DART AEROSPACE LTD		Work Order:	151599
Description: Crosstube Assembly (AS350/355 High Aft SS)		Part Number:	D350-748-243
Inspection Dwg: D350-748-243 Rev: A		Page 1 of 2

DART AEROSPACE LTD HAWKESBURY, ONTARIO, CANADA	
DRAWING NO. D350-748-243	REV. A SHEET 1 OF 4
TITLE CROSSTUBE (AS 350/355 HI AFT)	SCALE NTS
COPYRIGHT © 2015 BY DART AEROSPACE LTD THIS DOCUMENT IS PRIVATE AND CONFIDENTIAL AND IS SUPPLIED ON THE EXPRESS CONDITION THAT IT IS NOT TO BE USED FOR ANY PURPOSE OR COPIED OR COMMUNICATED TO ANY OTHER PERSON WITHOUT WRITTEN PERMISSION FROM DART AEROSPACE LTD.

DRAWING NO. D350-748-243	TITLE CROSSTUBE	REV. A	DART AEROSPACE LTD ENGINEERING ORDER		D.E.O. NO. D350-748-243-A-1	SHEET NO. SHEET 1 OF 1	SCALE NTS
DRAWN <i>qp</i>	CHECKED <i>ASS</i>	MFG. APPR. <i>[Signature]</i>	APPROVED <i>[Signature]</i>		DE APPR. <i>[Signature]</i>		
DATE 15.11.18	DATE 15.11.18	DATE 16.02.19	DATE FEB 19 2016		DATE 2016.02.19

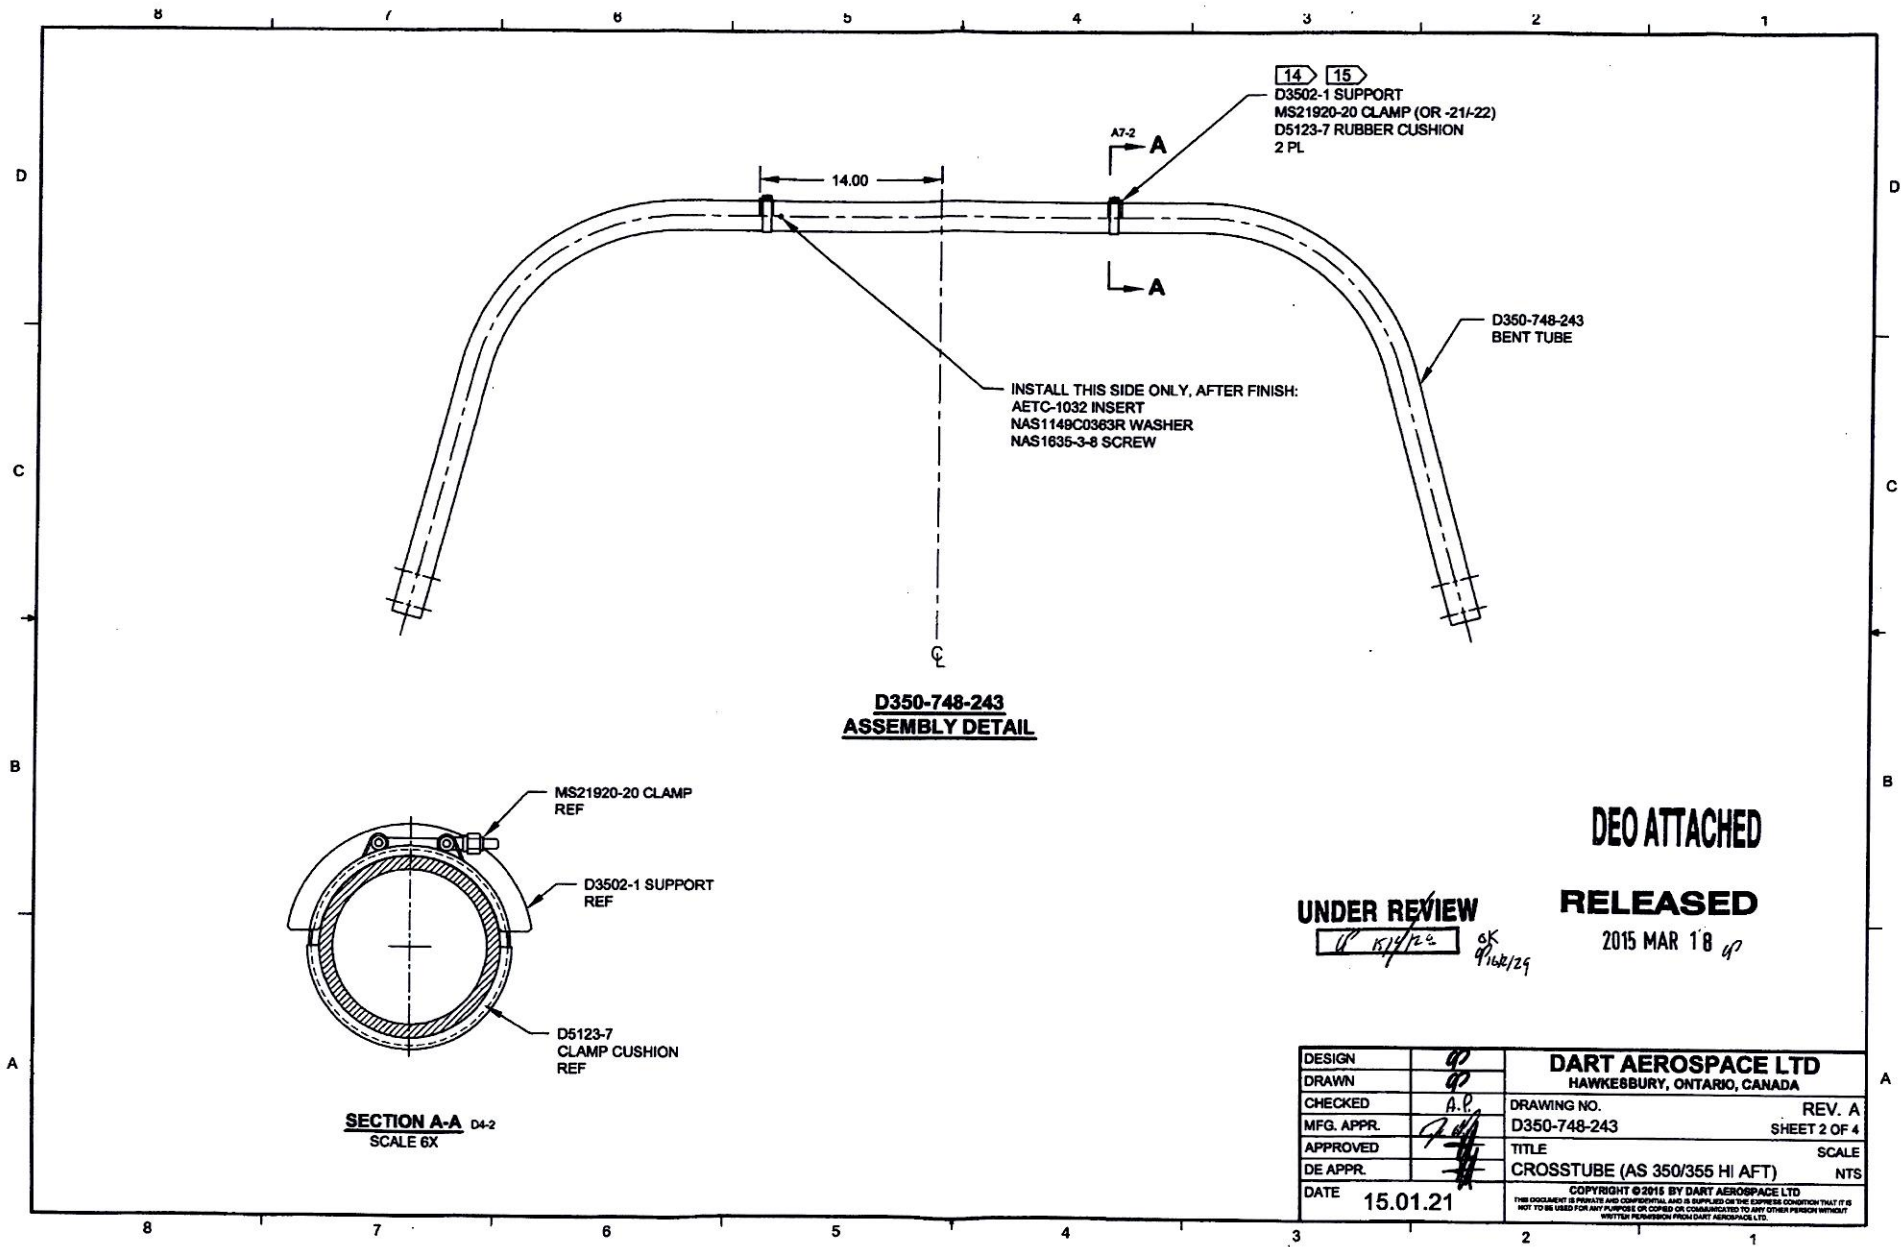
AMEND NOTE 2 (SHEET 1) AS FOLLOWS:

- 2) FINISH: PREPARE SURFACE PER DART QSI 005 4.1.4
 PRIME INSIDE AND OUTSIDE PER DART QSI 005 4.2
 PAINT OUTSIDE PER DART QSI 005 4.2
 OR
 POWDER COAT WHITE (4.3.5.2) PER DART QSI 005 4.3
